# Staff Report

Re: PLNSUB2019-00133 Preliminary Subdivision Plat and modifications to PLNSUB2018-00057 Planned Development for Moda on Main

## PRELIMINARY PLAT REVIEW COMMENTS

## MODA ON MAIN SUBDIVISION

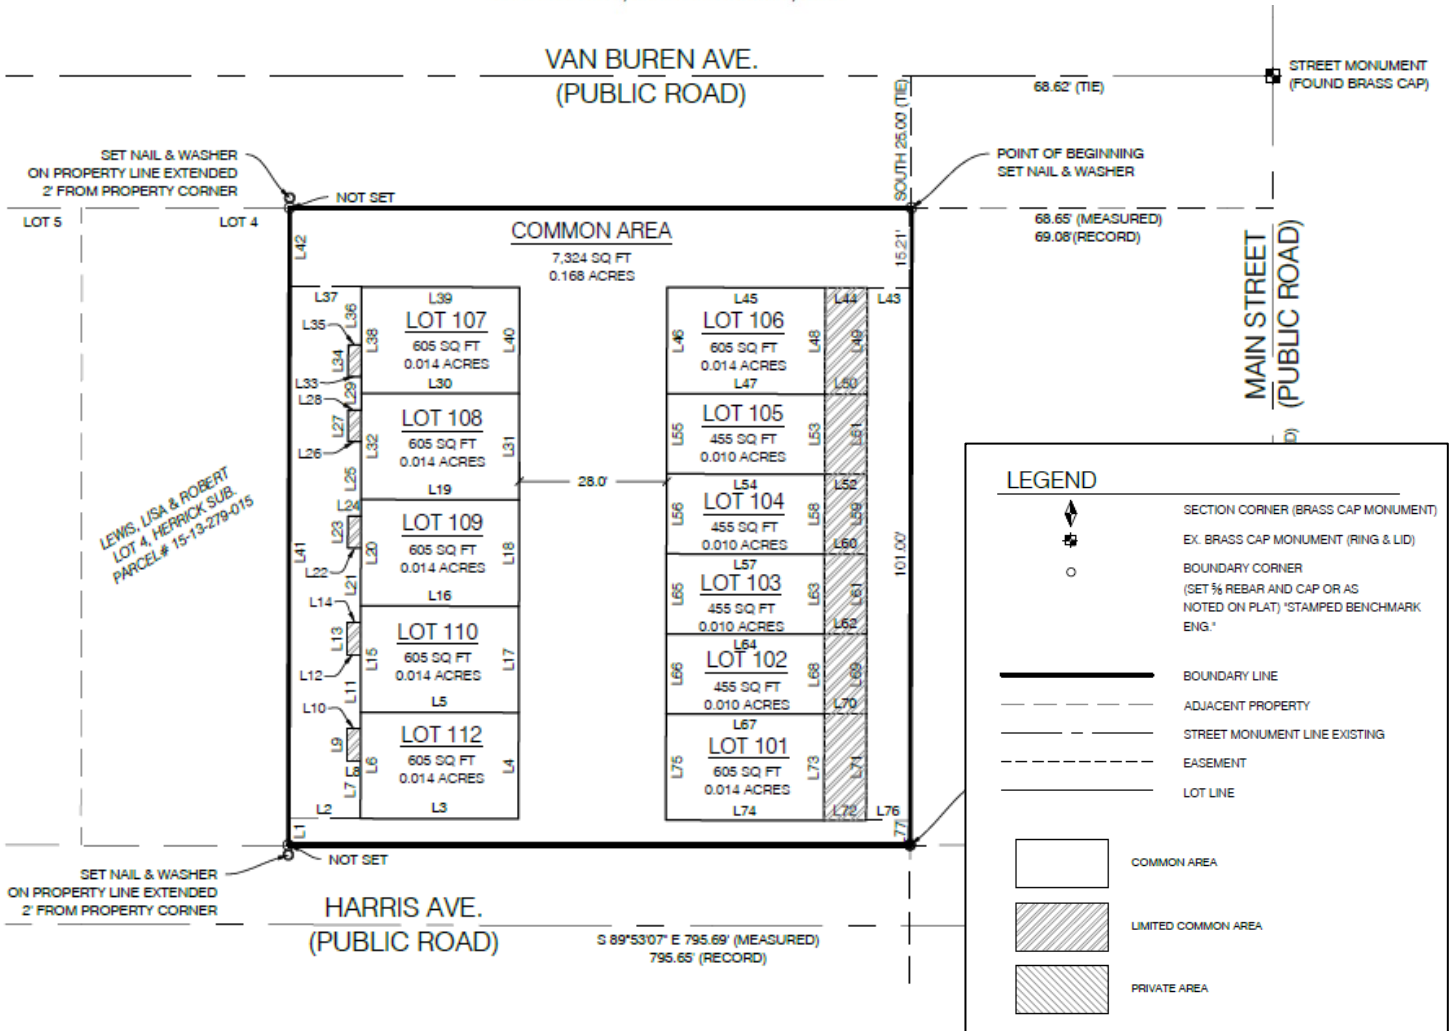
1. Planned Development amended approval will be required for proposed lot configuration whereas lots do not meet minimum lot size and width for CC zone, street frontage requirements. Planning will notify you when this can be presented to the Planning Commission.
2. Existing mature trees along Main to remain- work with City Urban Forester for recommendations on trimming or for protection during construction. 801-972-7818 or email urban.forestry@slgov.com

- 3) The planned development will need to address the reduction of the required 15 feet setback to 3.25 feet along Harris Avenue, and how the required CC landscaping will be addressed in the reduced setback area.

- 5) Bay windows, balconies and awnings that encroach into required setbacks will need to be addressed by the planned development, or they shall comply with table 21A.36.020.B, for Obstruction in Required Yards.

- 6) Fences exceeding 4 feet in height in a required front yard setback will need to be addressed by the planned development or special exception approval.
